May 1, 2026

LINCOLN PUBLIC SCHOOLS
LUX MIDDLE SCHOOL ROOF RENOVATION
LINCOLN, NEBRASKA

ADDENDUM #1

1 ROOF DEMOLITION PLAN - OVERALL
D1.0 3/64" = 1'-0"

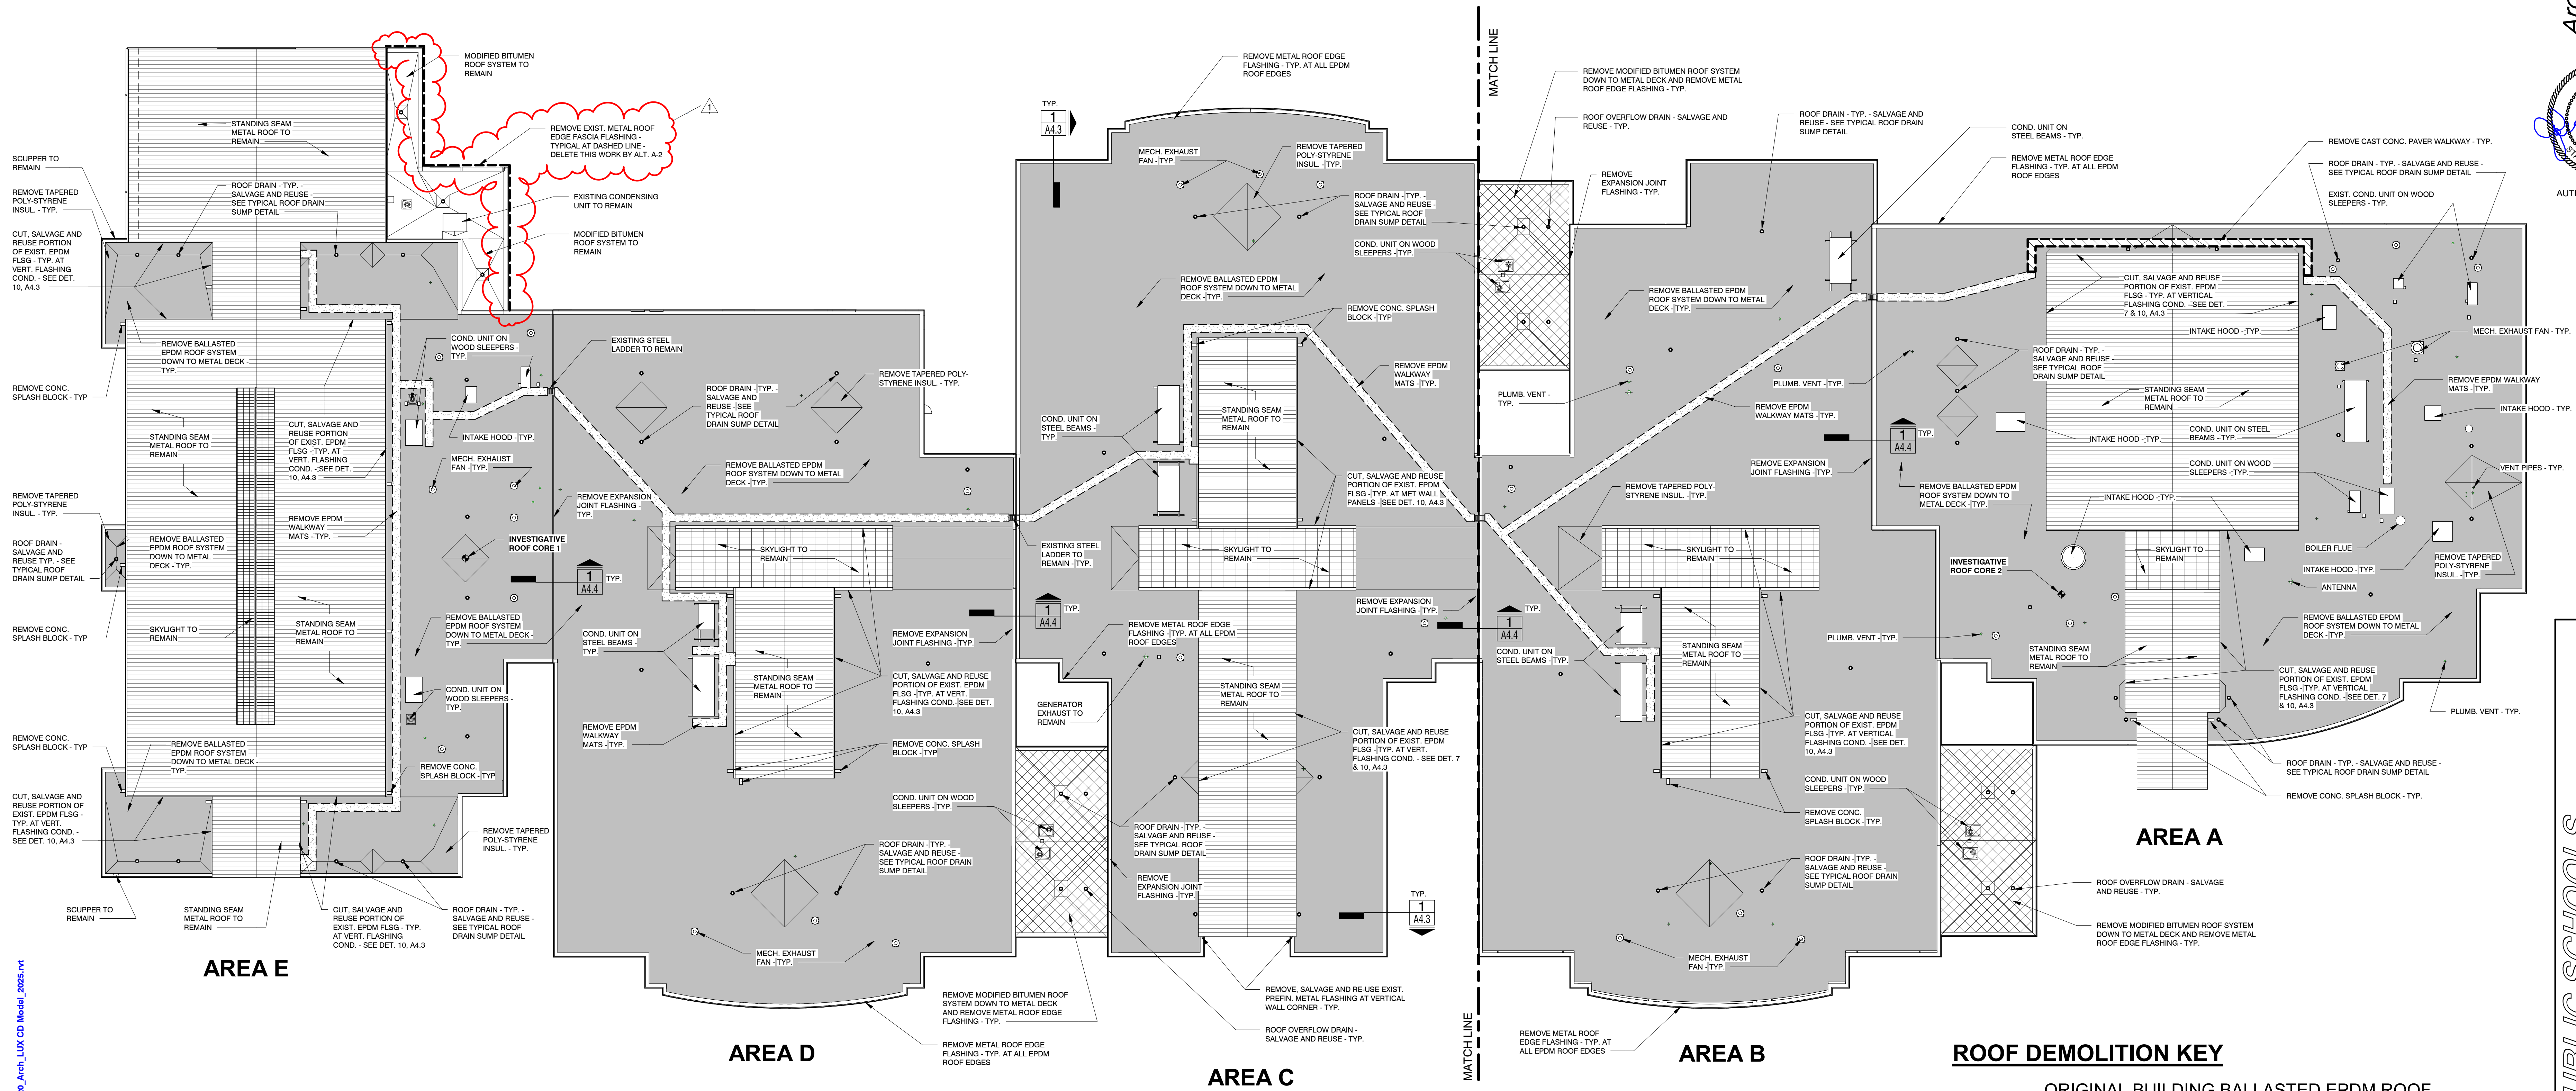
- A. At Detail 1 – Roof Demolition Plan – Overall – At the 2021 Addition Modified Bitumen roof edge, add a note to: “Remove exist. metal roof edge fascia flashing – Typical at dashed line – Delete this work by Alt. A-2”.

REFLECTED CEILING PLAN - WEST
 1/16" = 1'-0"

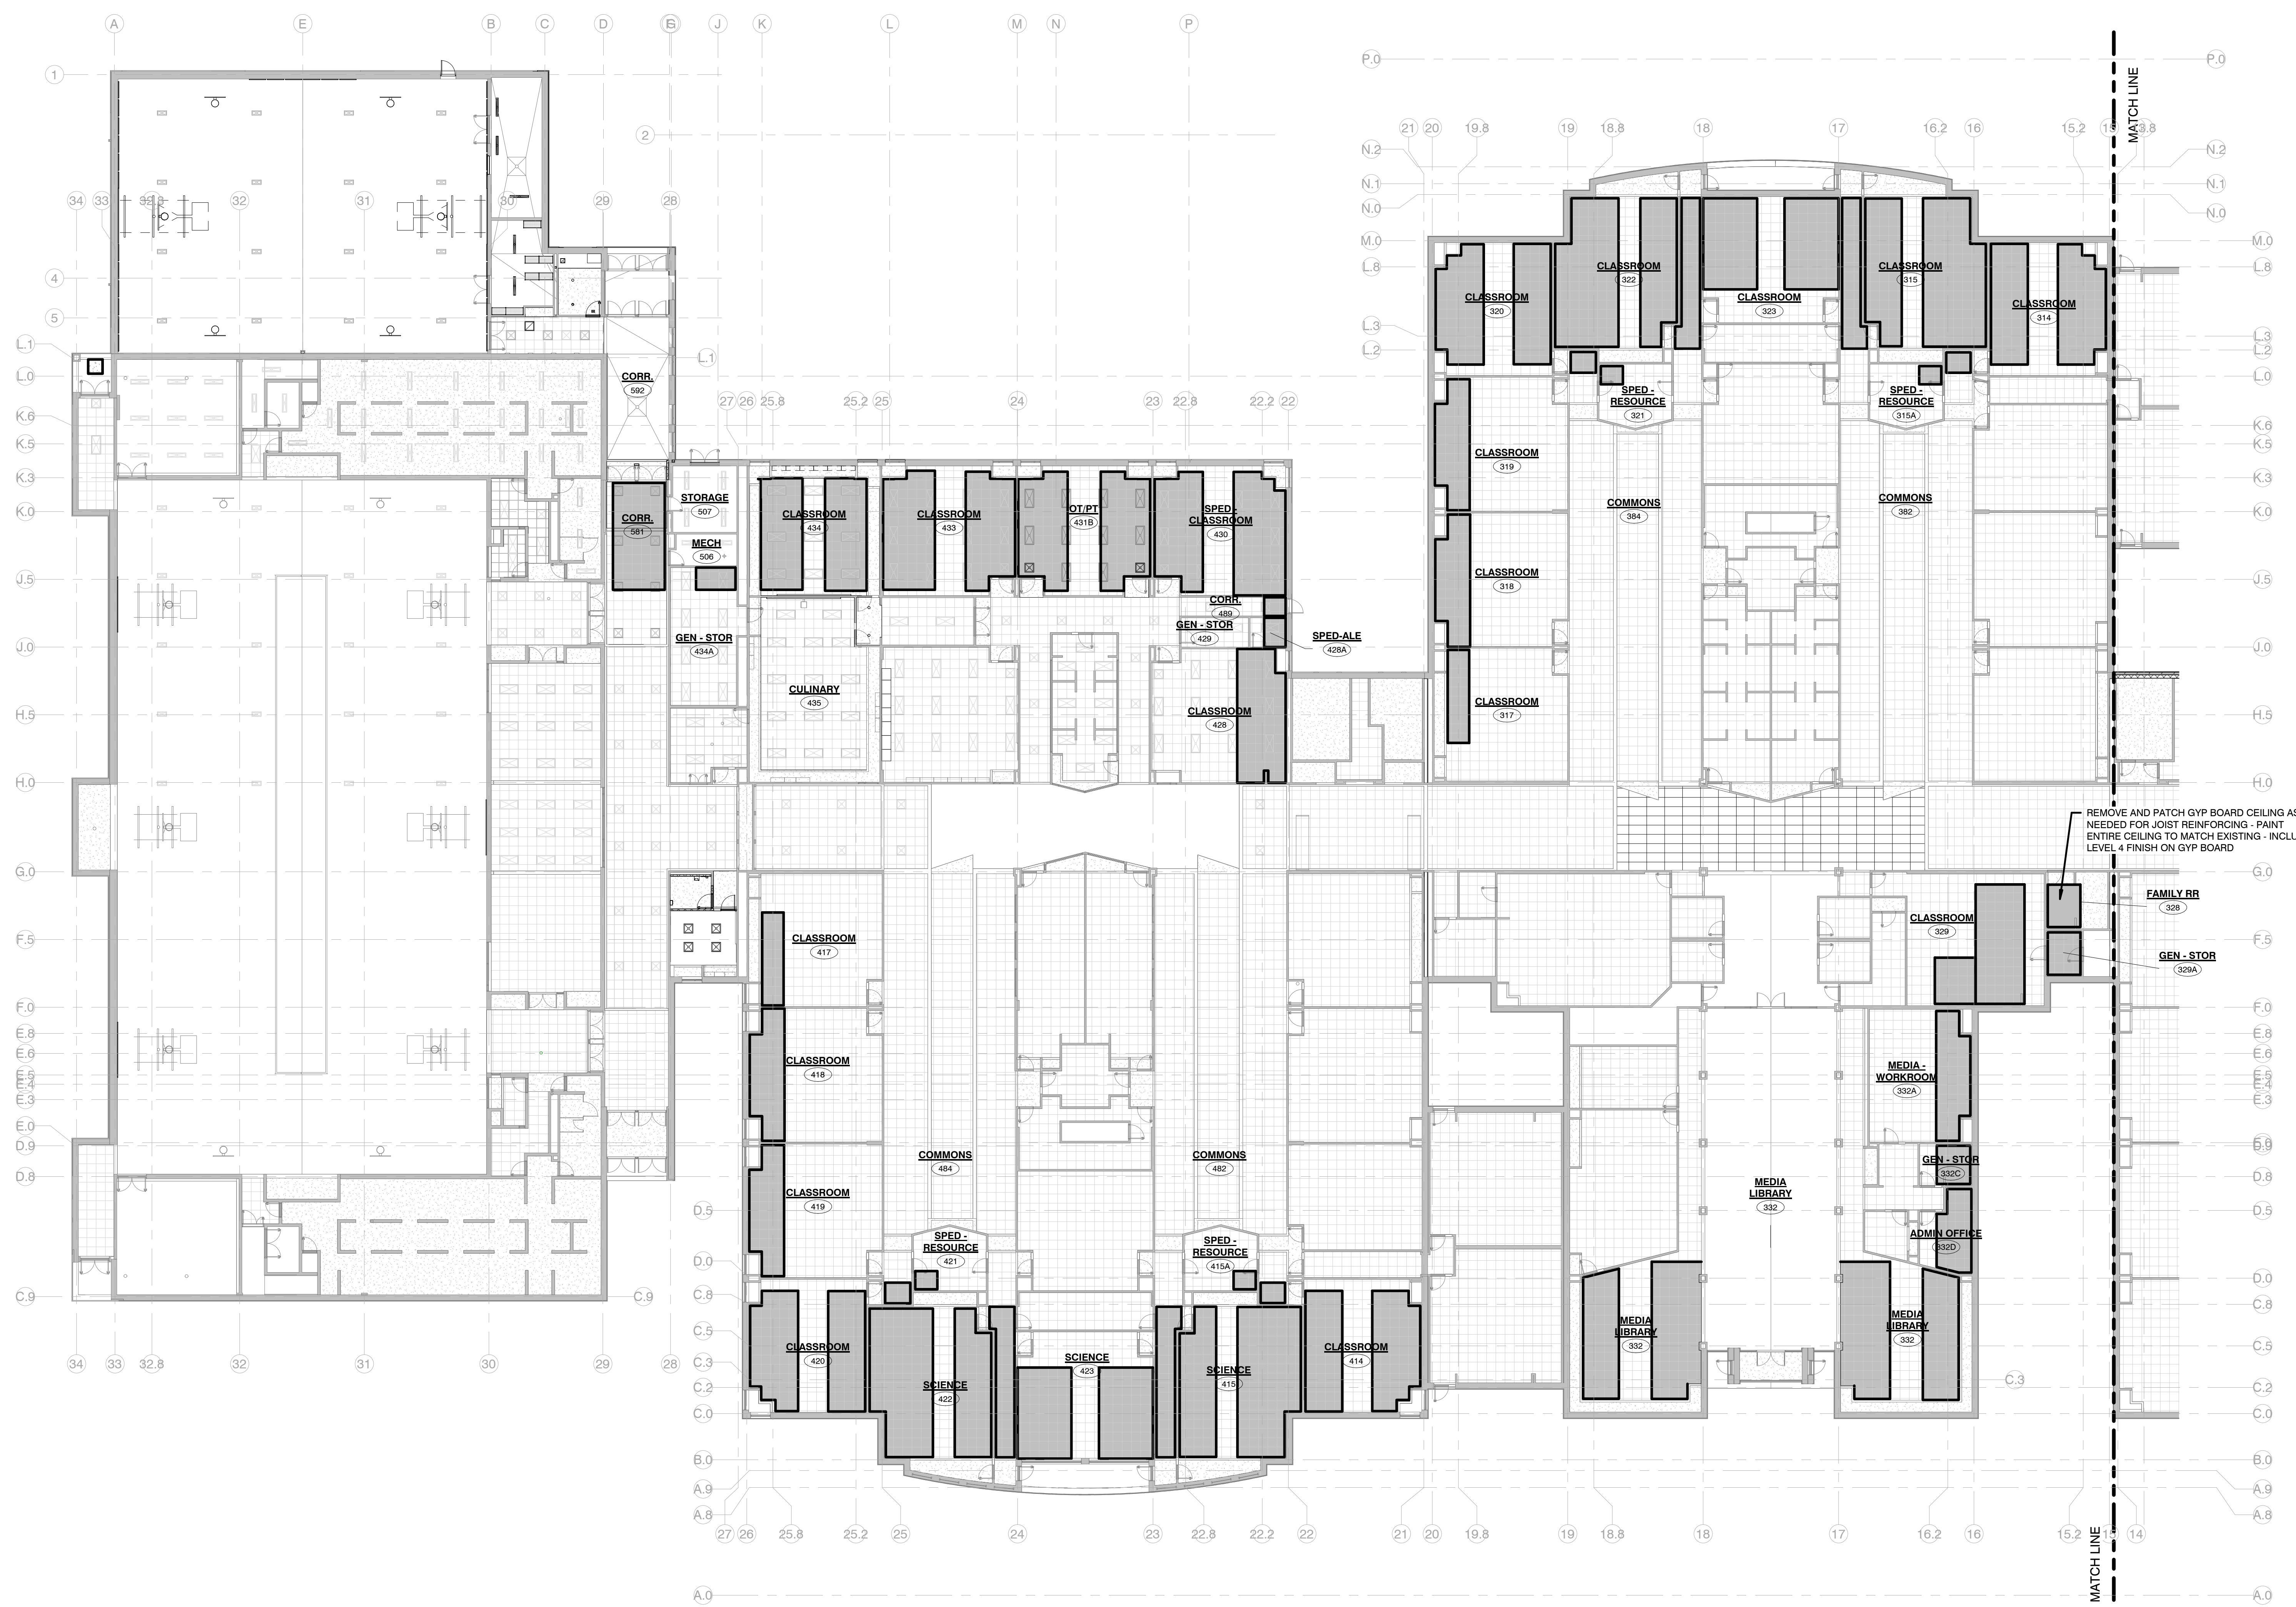
- A. At the ‘Joist & Ceiling Renovation General Notes, revise general note No. 6 to say the following: “6. Joist reinforcing shall occur prior to, at the same time as, or as soon after roof ballast removal as possible at each roof area”.

1 ROOF RENOVATION PLAN - OVERALL
A4.0 3/64" = 1'-0"

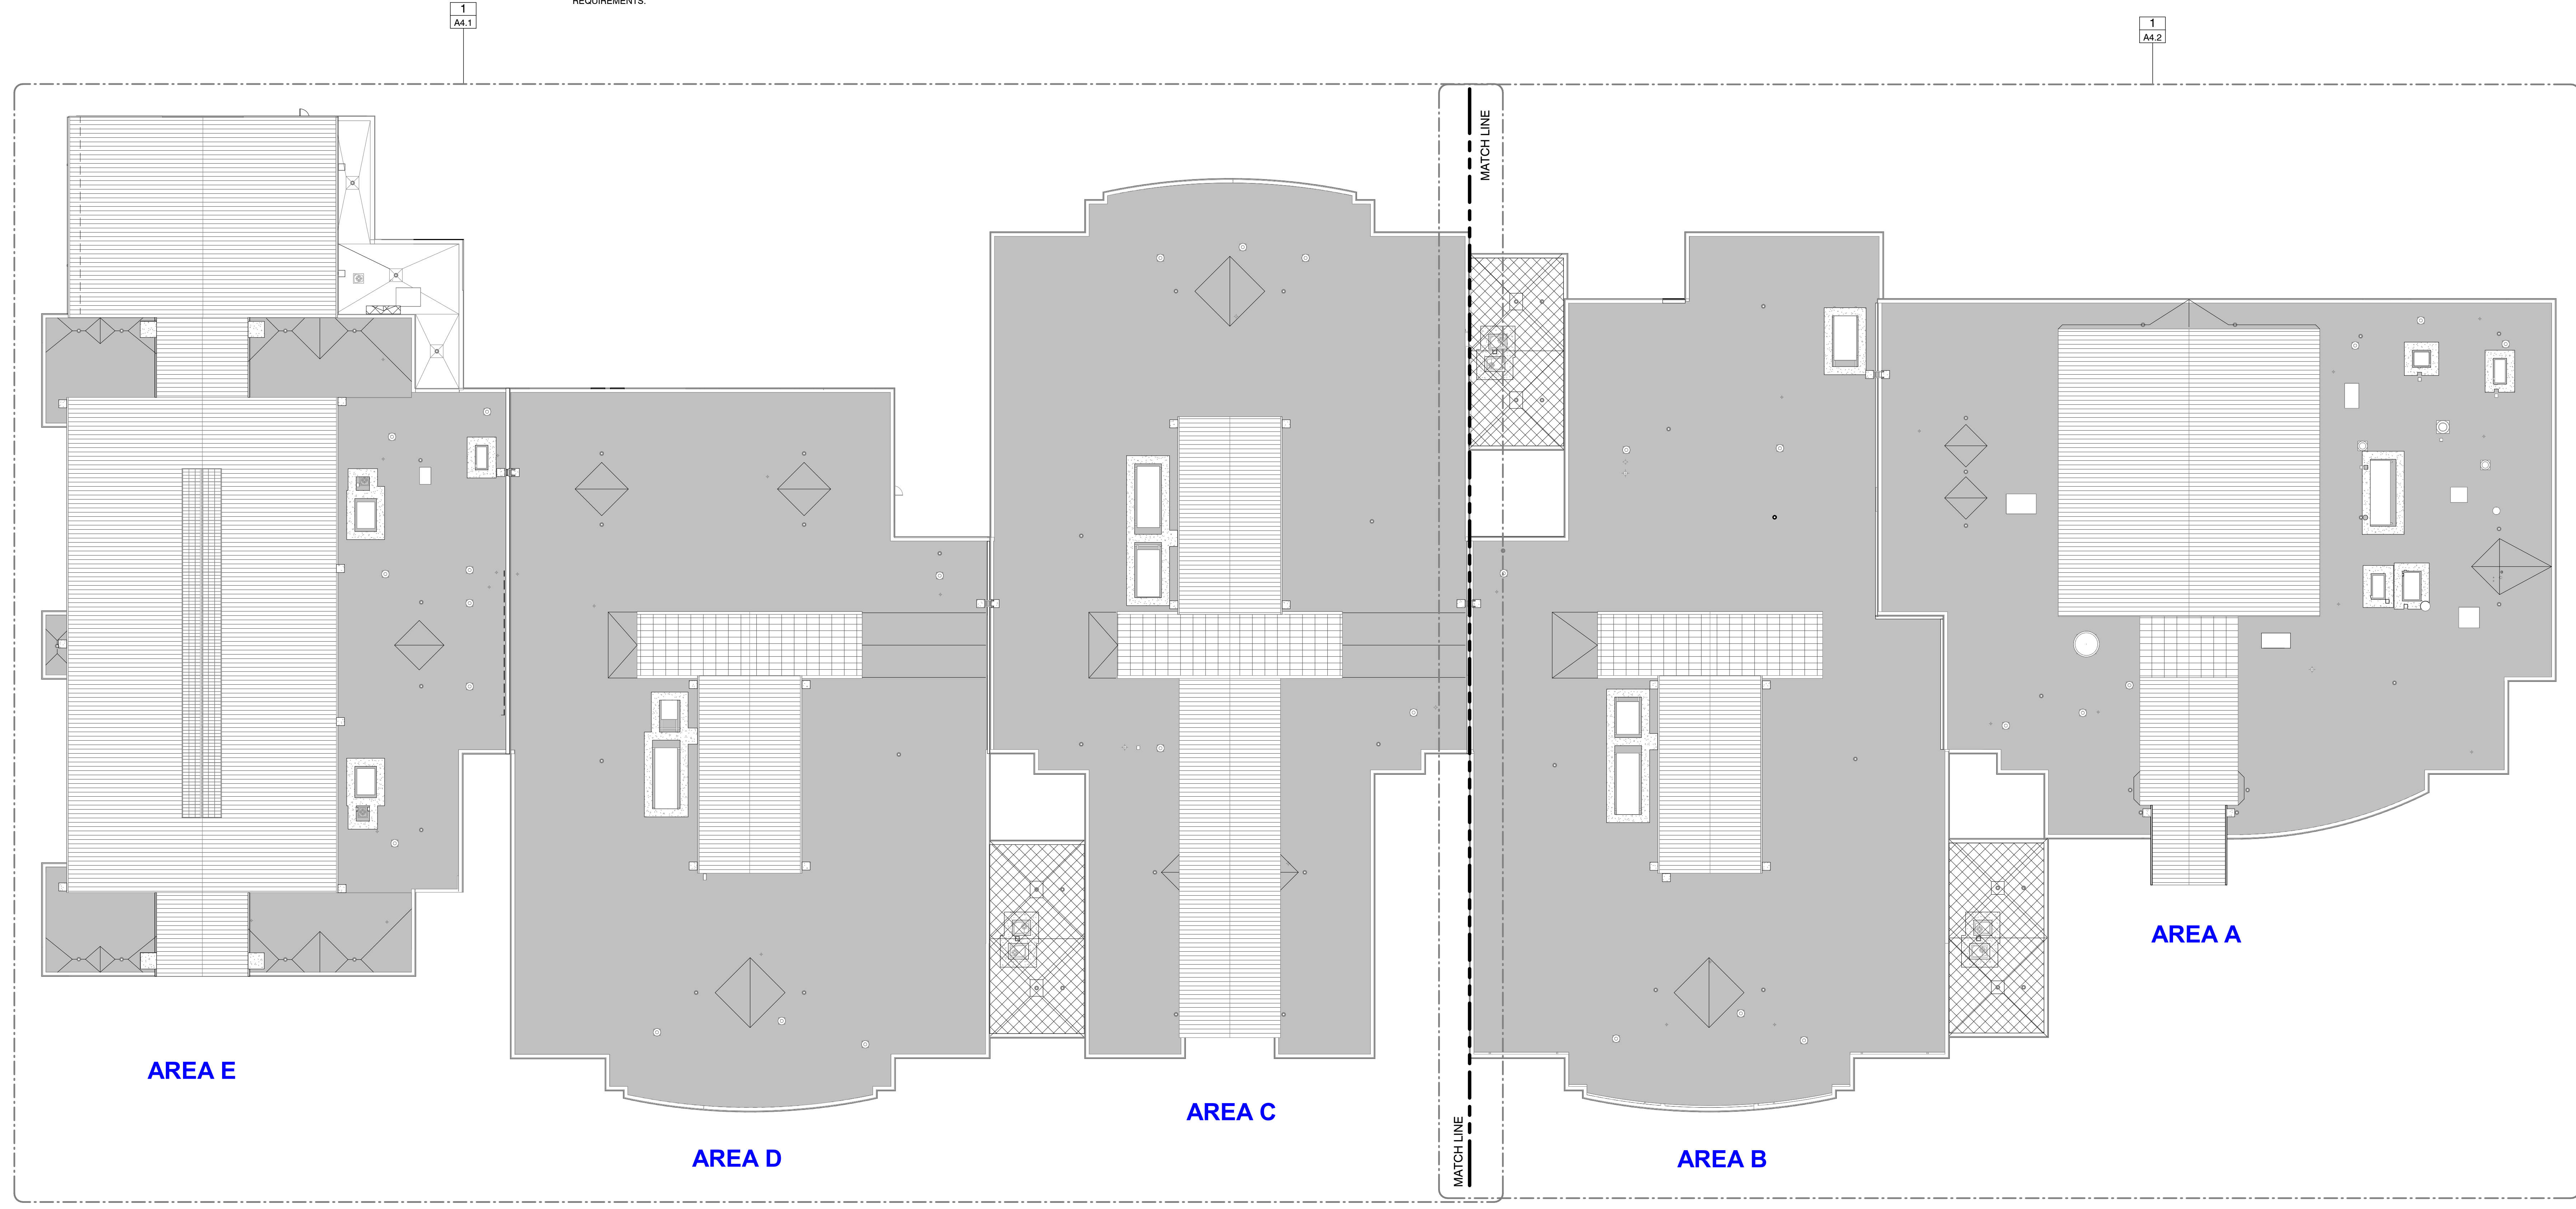
- A. At the ‘Roof Renovation General Notes’, delete note 8 and add the following: “8. By Deduct Alternate A-1 – Delete the work to remove and replace backer rod and sealant at masonry joints above roof renovation areas including: brick expansion joints (approx. 14'-8" O.C. - F.V.); cast stone control joints (approx. 7'-4" O.C. - F.V.); and continuous horizontal joints between cast stone and brick at masonry walls above roof renovation areas.”
